Response to the Comments from New York State Department of Environmental Conservation

Subject: Draft Final Decision Document – Mini Risk Assessment for the ~~Inhibited~~
Red Fuming Nitric Acid (IRFNA) Disposal Site (SEAD-13)
Seneca Army Depot
Romulus, New York

Comments Dated: December 12, 2002

Date of Comment Response: March 7, 2003

FIGURE 2-7

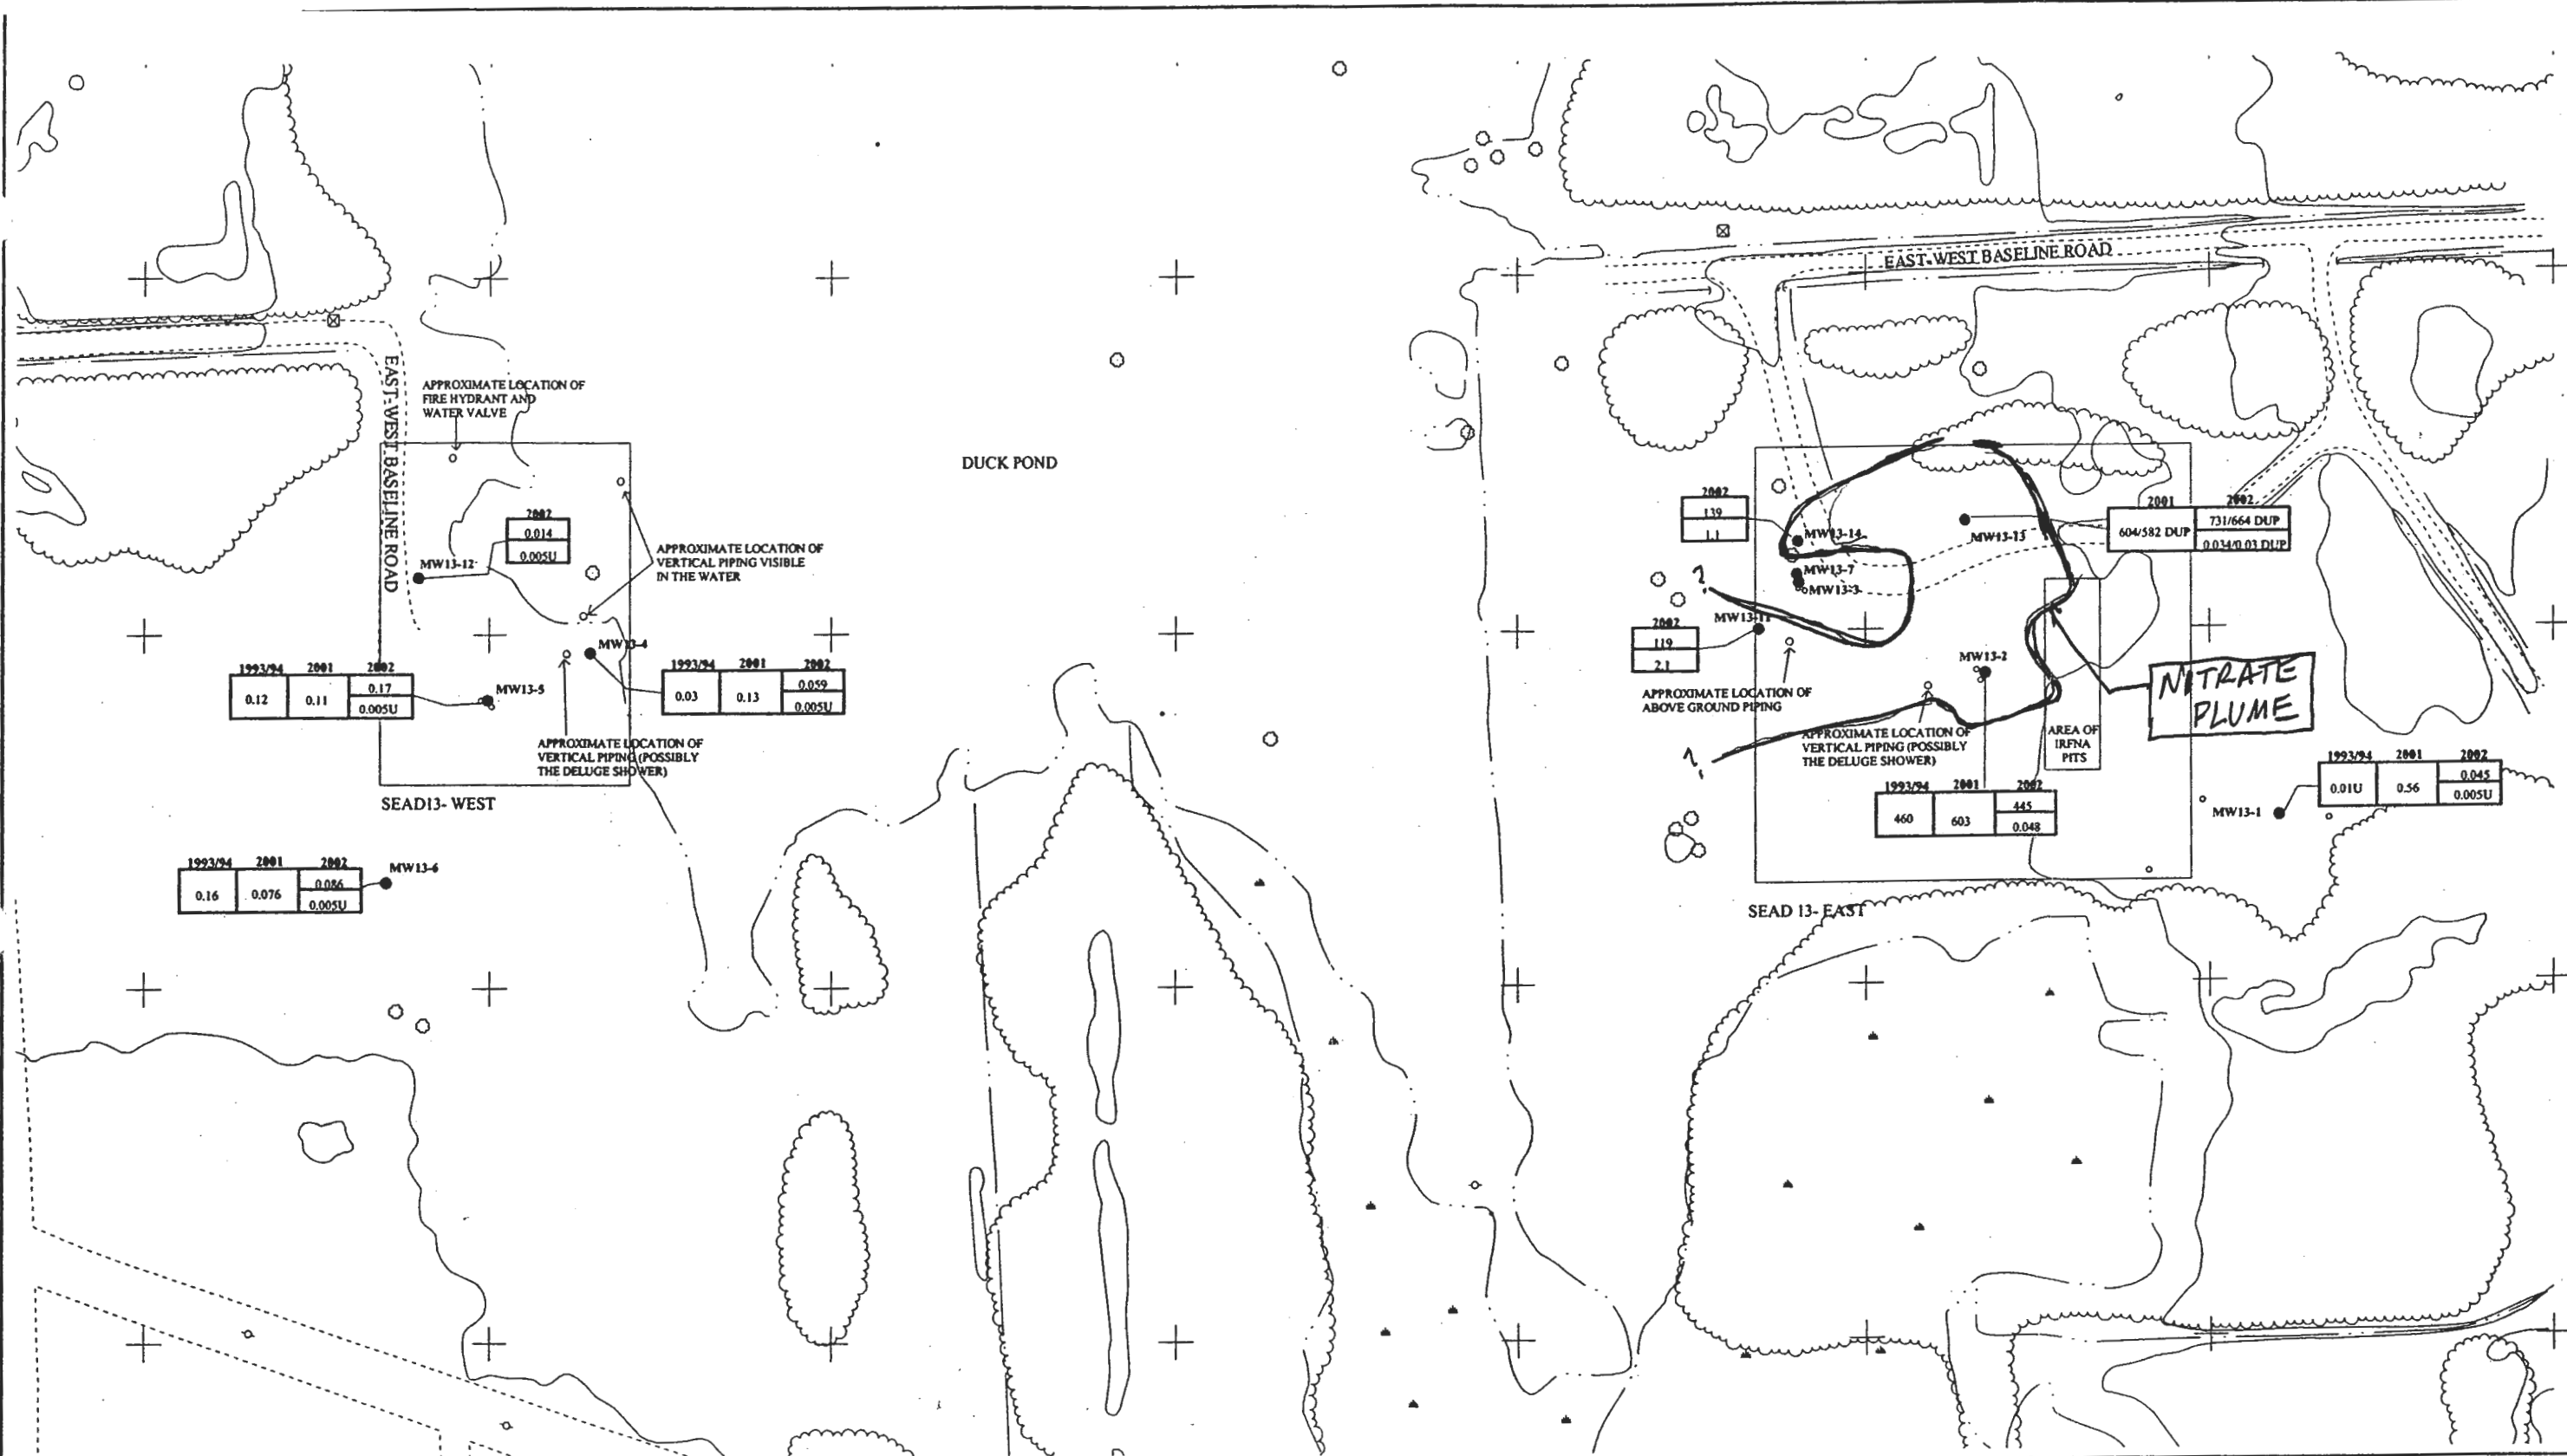
Comment 6: Has the groundwater contamination been sufficiently delineated? If so, please provide a plume sketch, depicting both nitrate/nitrite and metals contamination.

Comment 8: Although discussed in the text, there should be a figure denoting the direction of groundwater flow.

Comment 14: Figures 2-1 through 2-7: On these figures it is unclear where the suspected IRFNA pits are on the west side of the site. Therefore it is difficult to support the Army’s location of monitoring wells and sampling points on the west portion of the site. Also, groundwater direction should be indicated where appropriate.

As shown on Figure 2-7, a review of groundwater sampling parameters shows that the pH of the groundwater at SEAD-13 is not lowered and is in the same range as the pH of groundwater at other background locations at SEDA. The pH measured at the site does not cause additional leaching of metals.

Response 6: The groundwater contamination has been sufficiently delineated. Figure 2-7 provides a plume sketch, as well as nitrate/nitrite data.

Response 8: Agreed. The direction of groundwater flow has been added to Figure 2-7.

The direction of groundwater flow has been added to a new Figure 2-?. In general, groundwater flows toward the Duck Pond.
